Subject: **San Onofre Nuclear Generating Station Units 2 and 3**
Docket Nos. 50-361 and 50-362
Proposed Change Number NPF-10/15-551
License Amendment Request, "Reactor Coolant System (RCS) Pressure and Temperature Limits Report (PTLR)"

DESCRIPTION AND NO SIGNIFICANT HAZARDS ANALYSIS FOR PROPOSED CHANGE NPF-10/15-551 RELOCATION OF REACTOR COOLANT SYSTEM (RCS) PRESSURE AND TEMPERATURE CURVES FROM THE TECHNICAL SPECIFICATIONS TO A PRESSURE AND TEMPERATURE LIMITS REPORT (PTLR) San Onofre Nuclear Generating Station Units 2 and 3

~~FIGURE 3.4.3-5~~

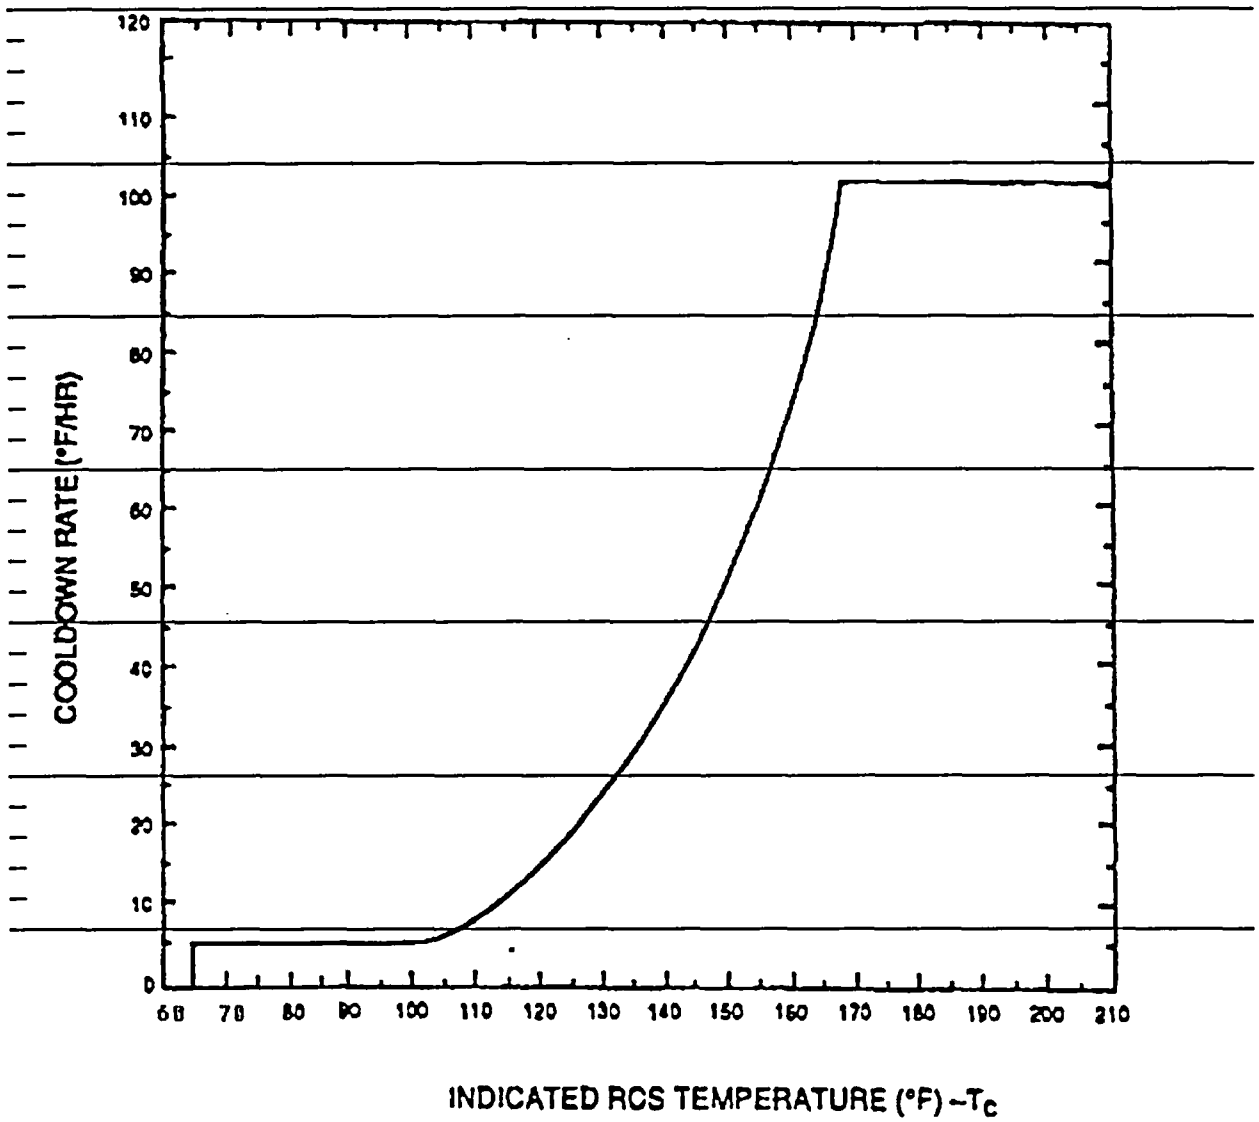
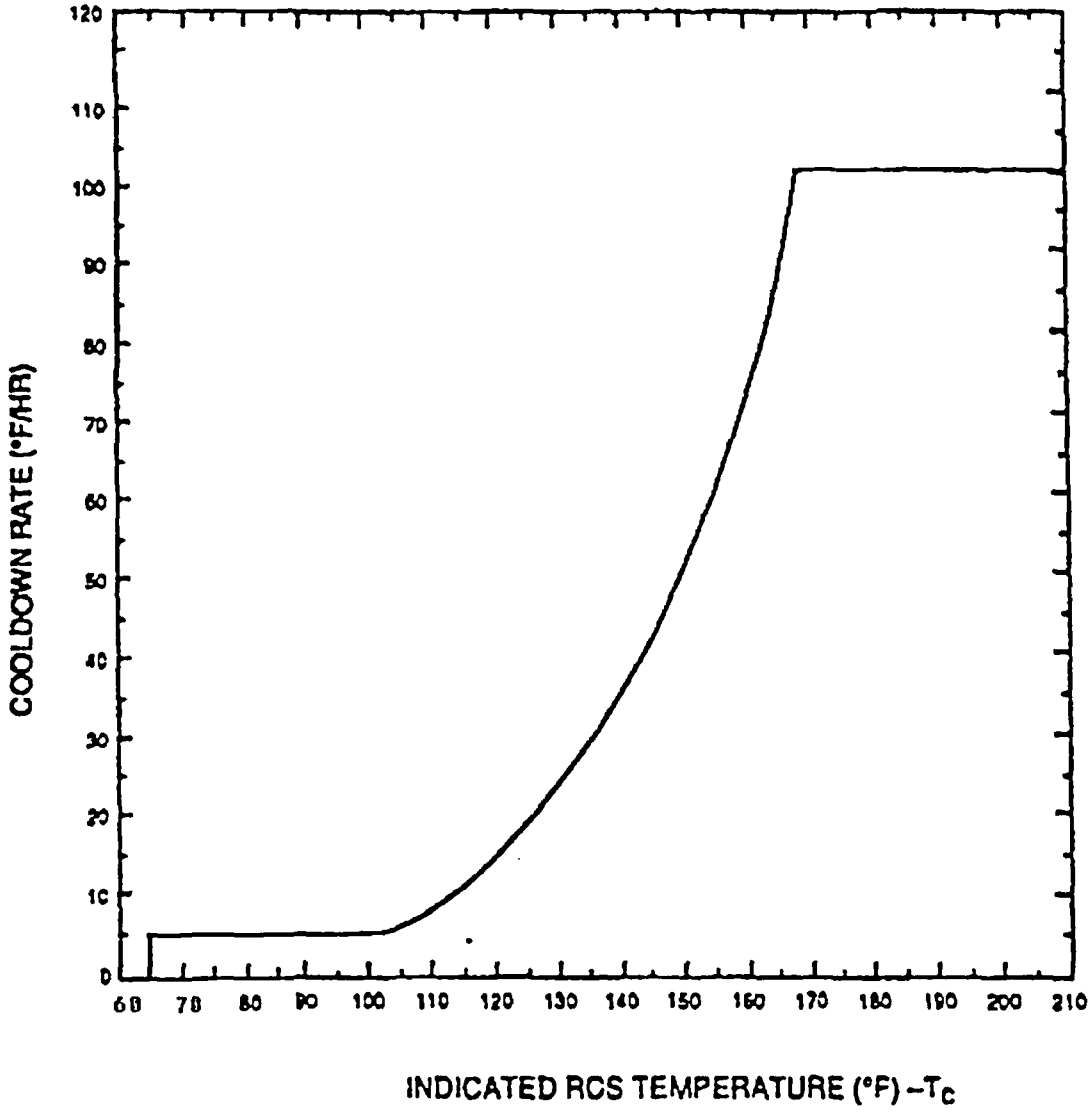
FIGURE 3.4.3-5
DELETED

~~FIGURE 3.4.3-1~~

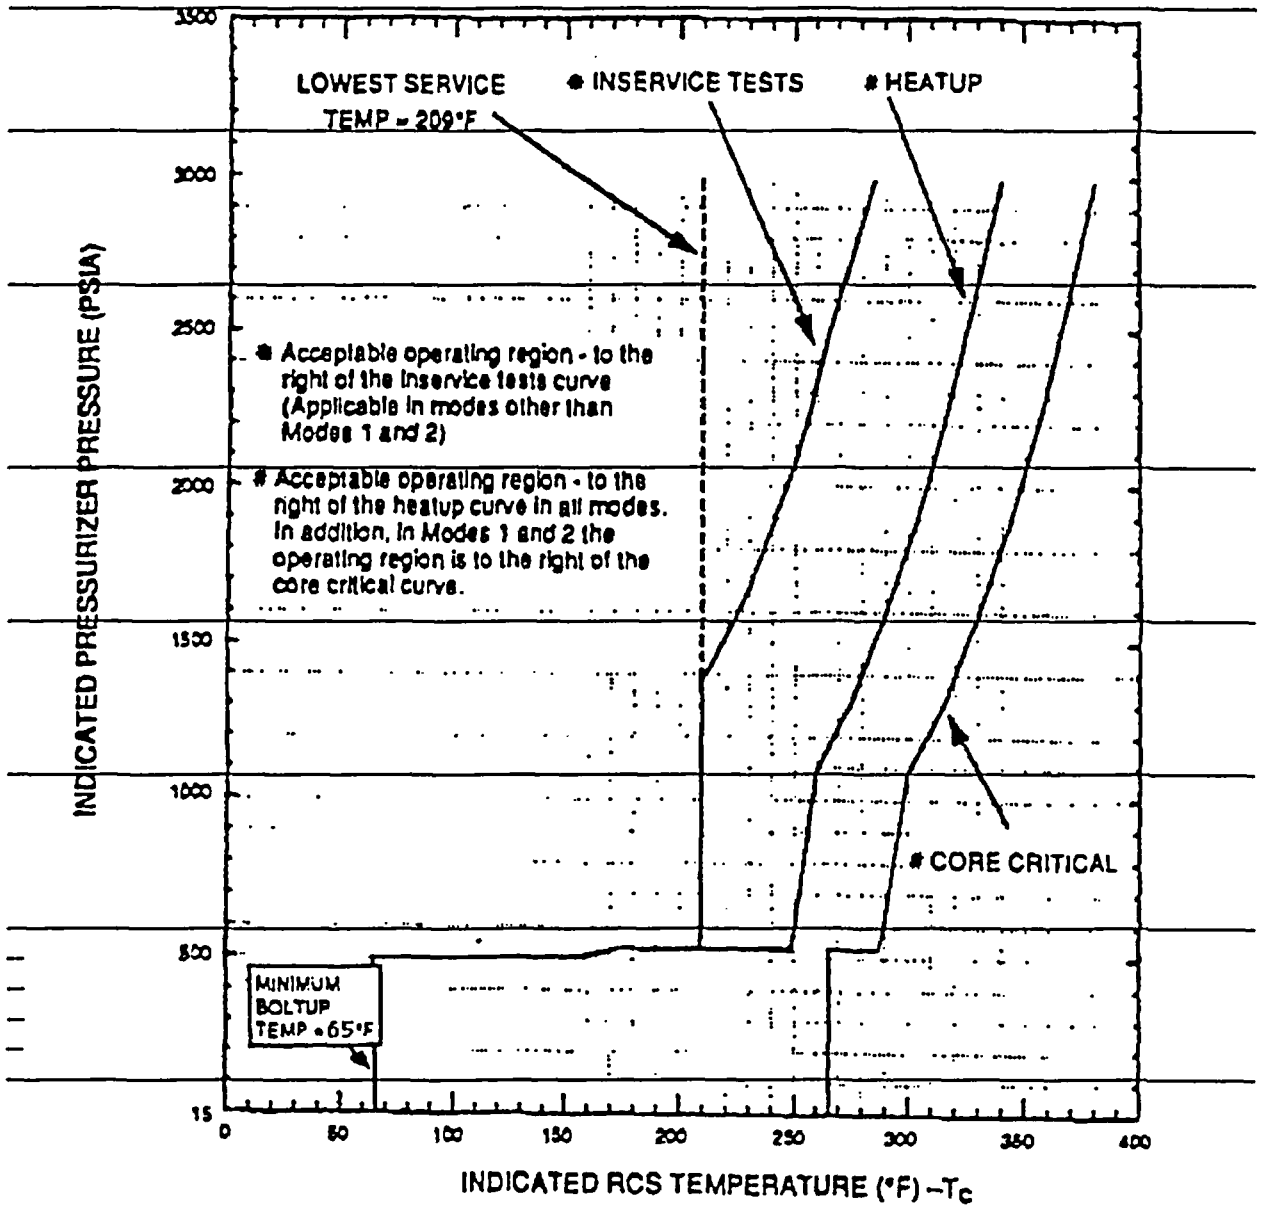
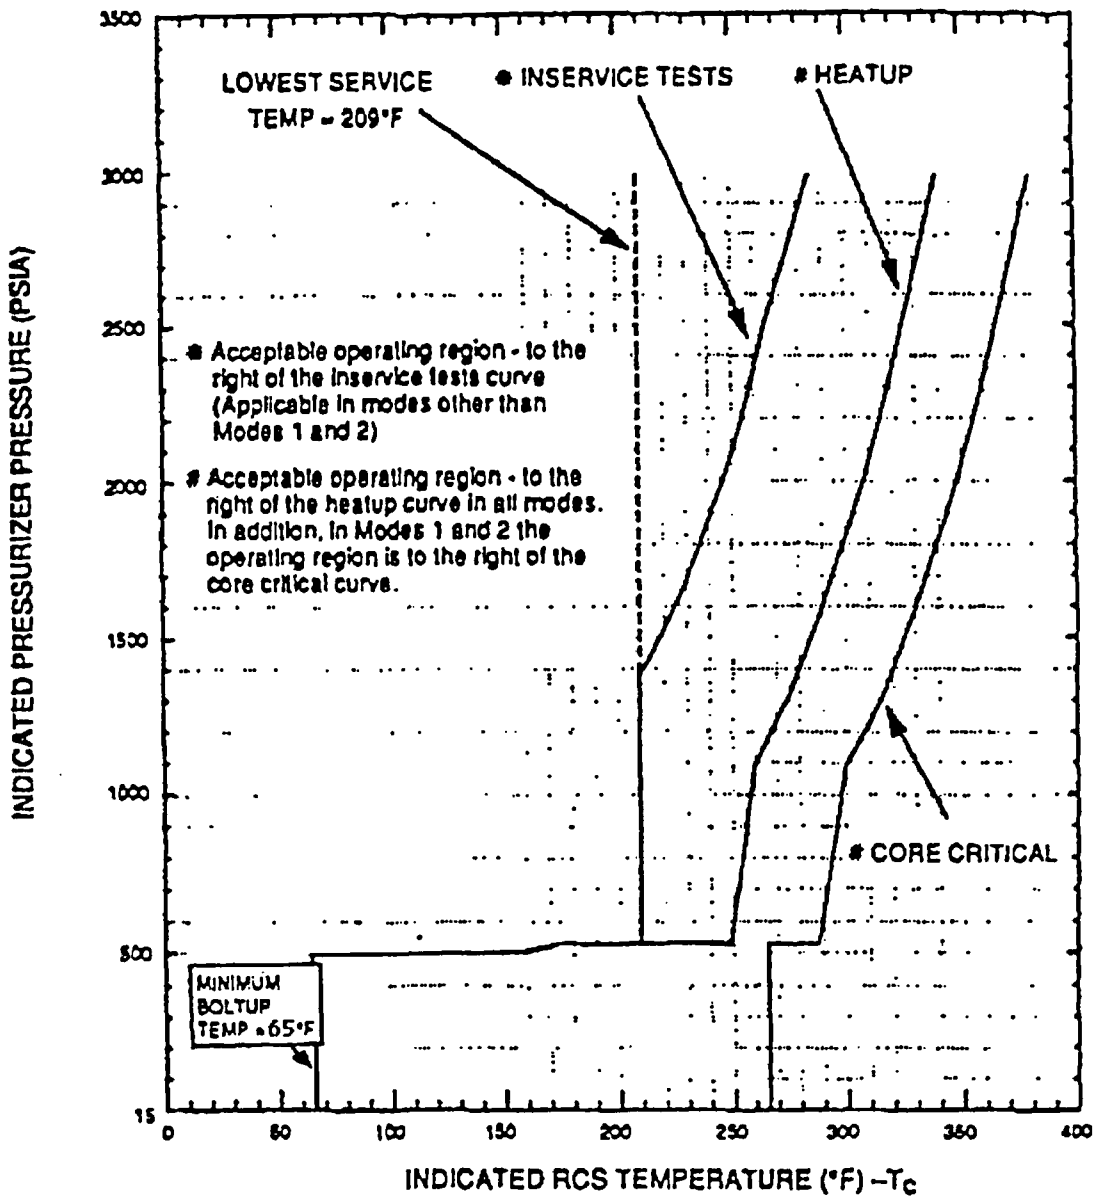
----------NOTE----------
SIT isolation or depressurization to less than the ~~Figure 3.4.3-2 limit~~limits in the PTLR is only required when SIT pressure is greater than or equal to the maximum RCS pressure for the existing RCS cold leg temperature allowed by the ~~P/T limit curves provided in Figure 3.4.3-1 and Figure 3.4.3-2~~PTLR.

FIGURE 3.4.3-1
DELETED

~~FIGURE 3.4.3-2~~

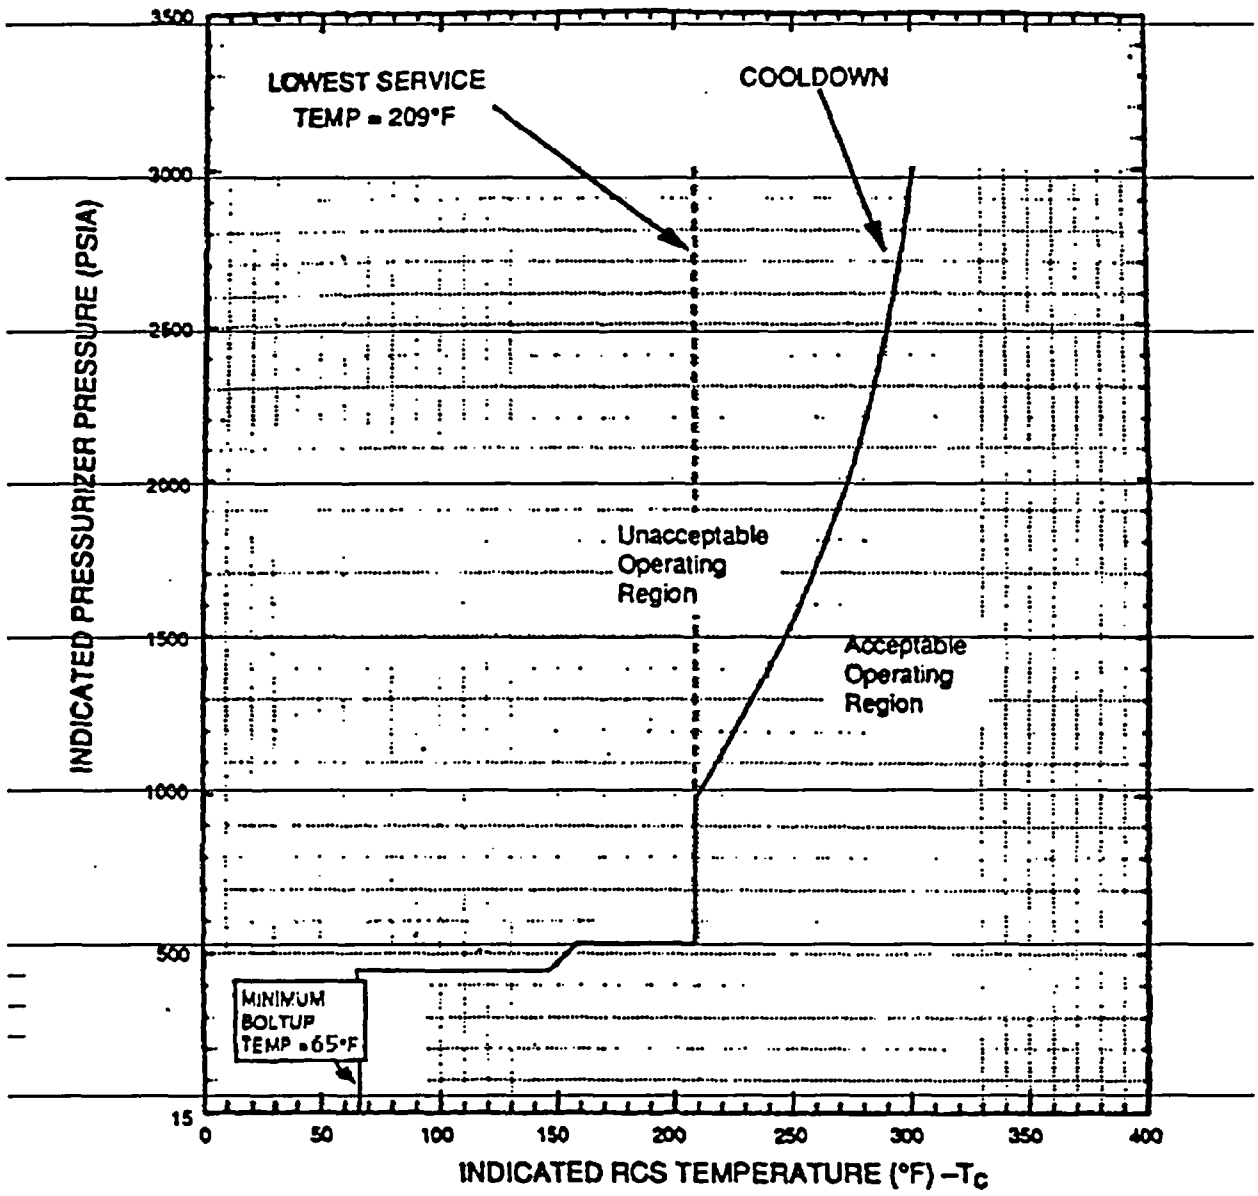
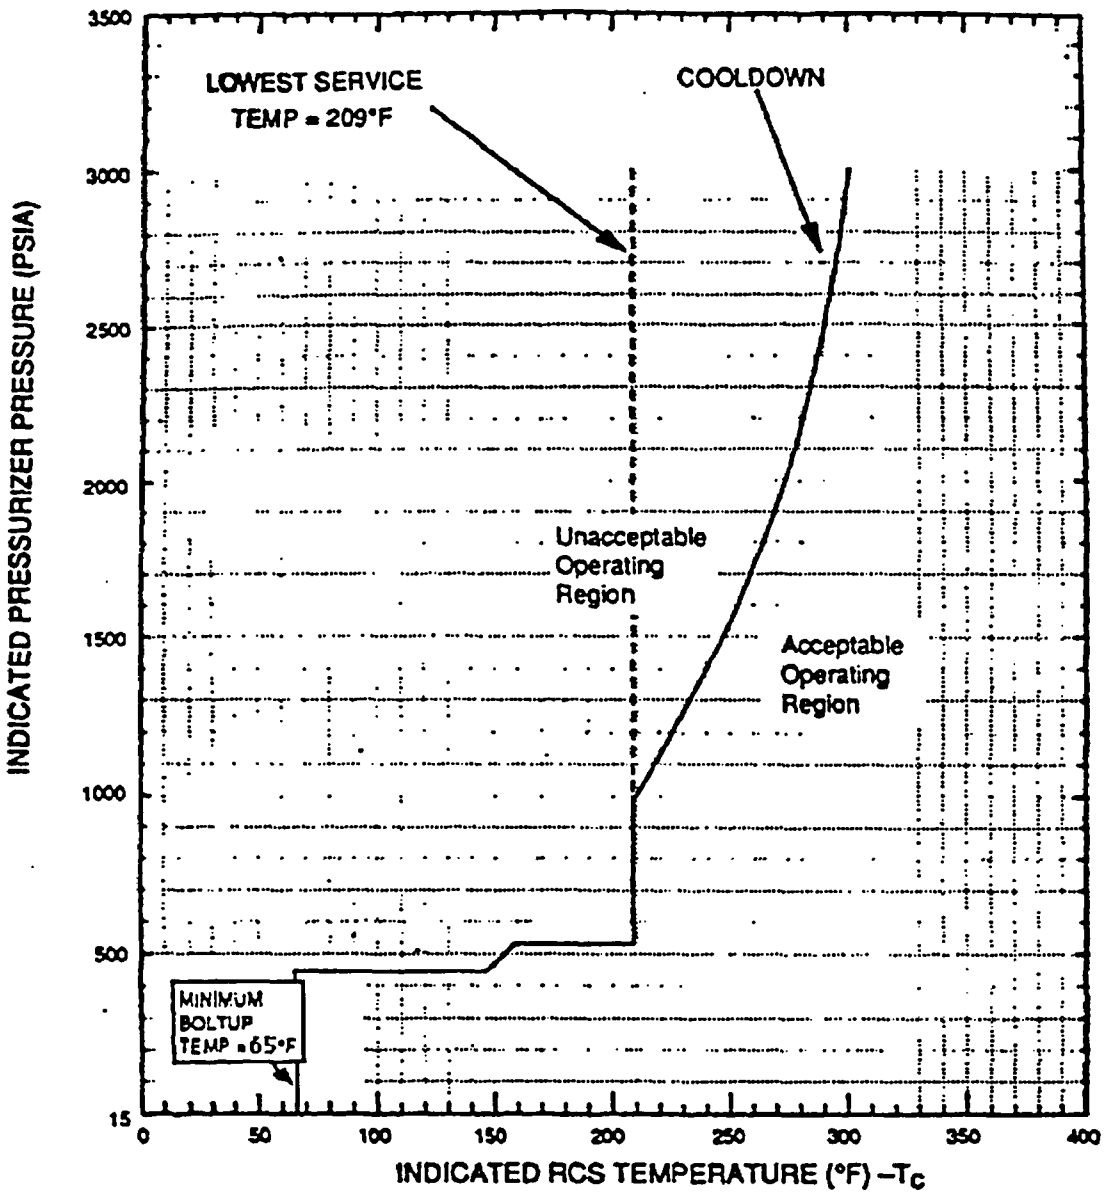
LCO 3.4.12.1 No more than two high pressure safety injection pumps shall be OPERABLE, the safety injection tanks shall be isolated or depressurized to less than the limit specified in ~~Figure 3.4.3-2~~the PTLR and at least one of the following overpressure protection systems shall be OPERABLE:

FIGURE 3.4.3-2
DELETED

~~FIGURE 3.4.3-3~~

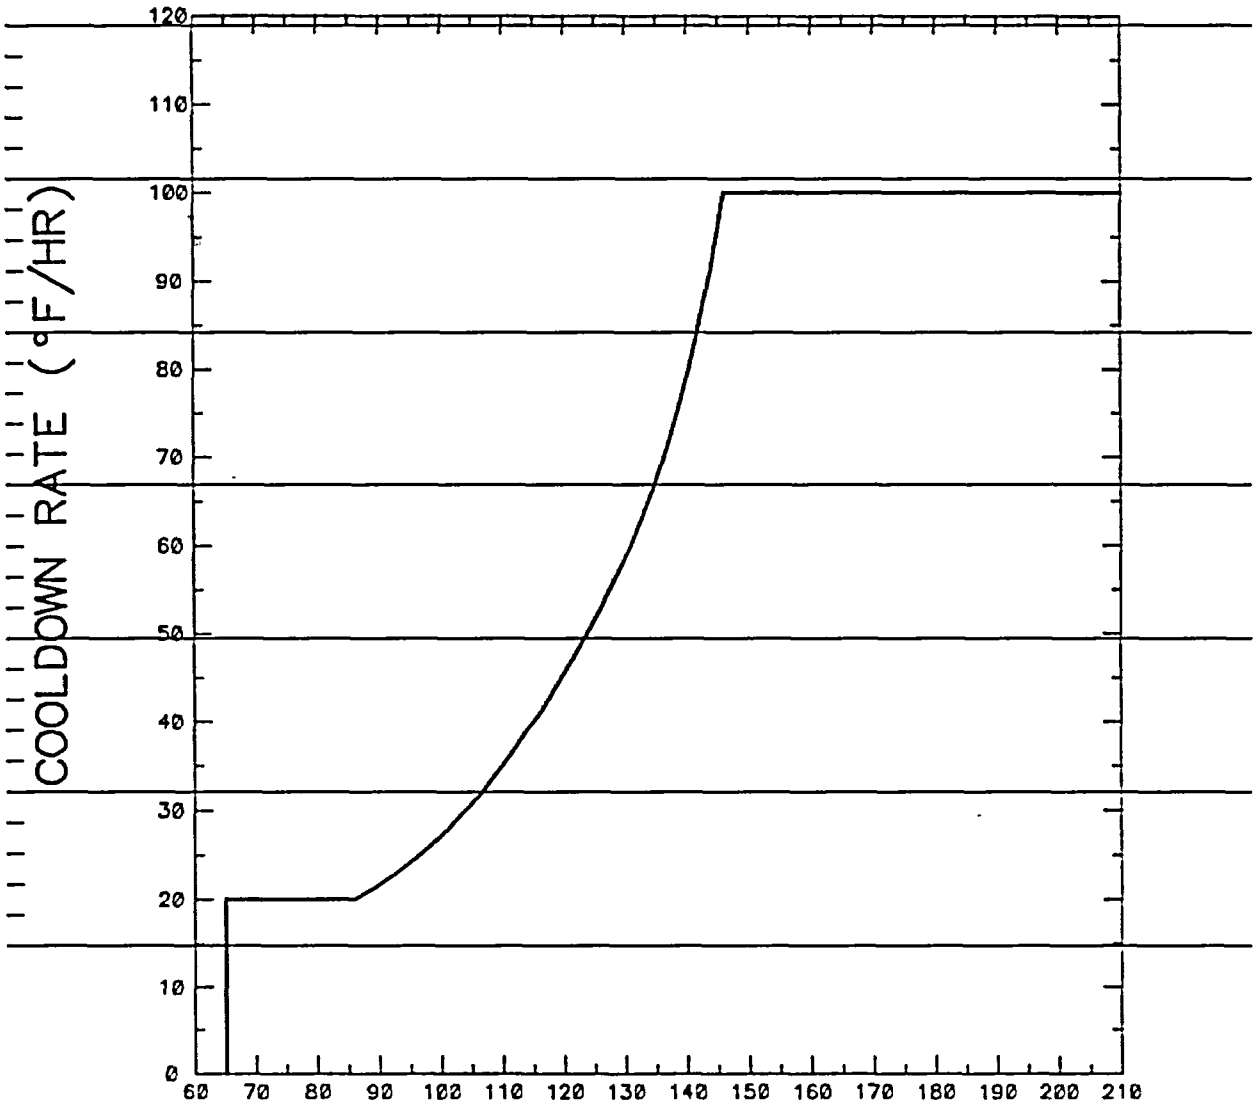
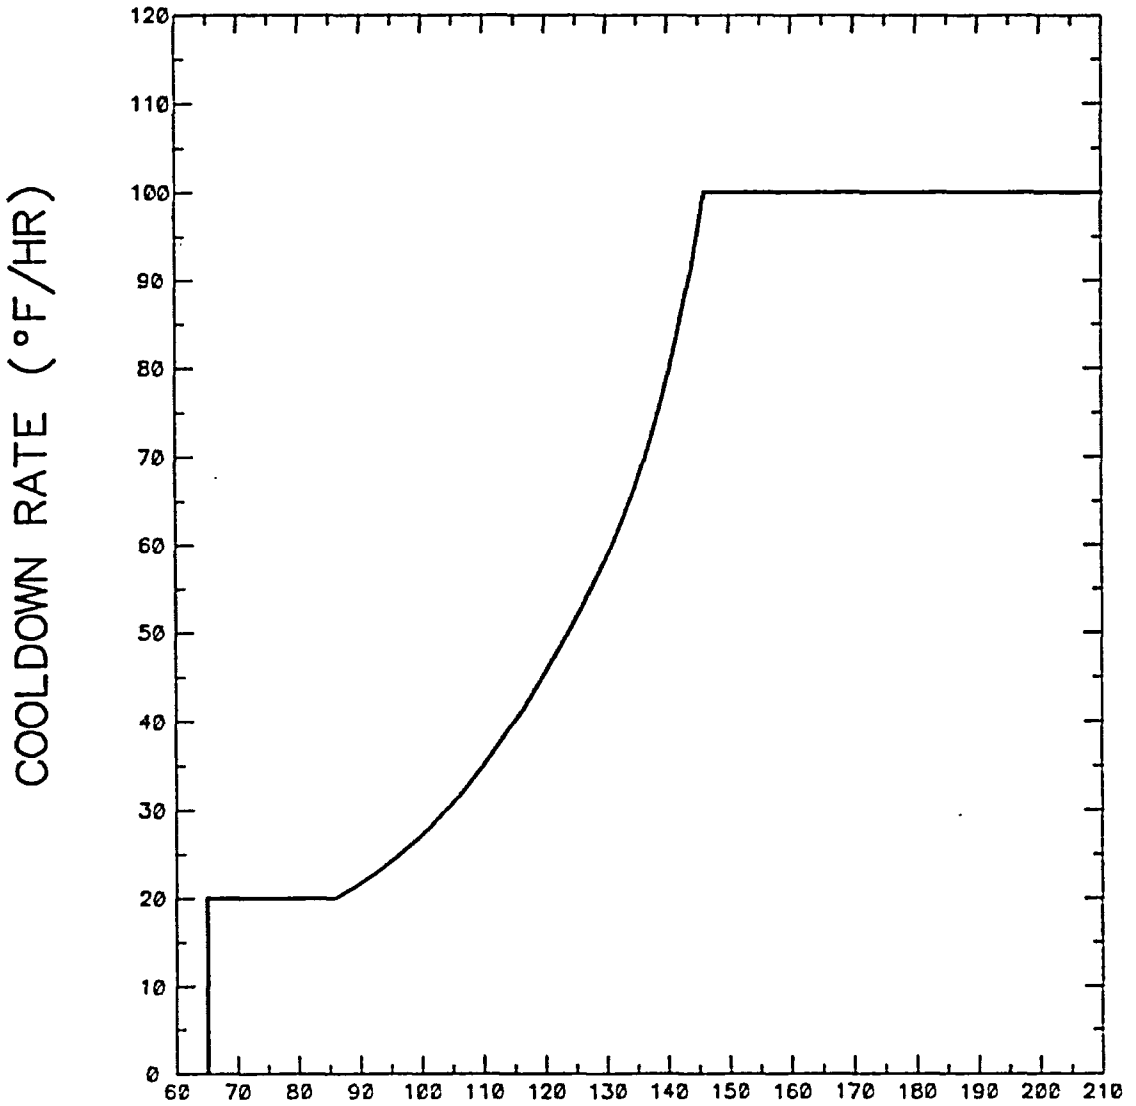
~~b. A maximum cooldown as specified by Figure 3.4.3-3 in any 1-hour period with RCS cold leg temperature less than or equal to 147°F. A maximum cooldown of 100°F in any 1-hour period with RCS cold leg temperature greater than 147°F.~~

FIGURE 3.4.3-3
DELETED
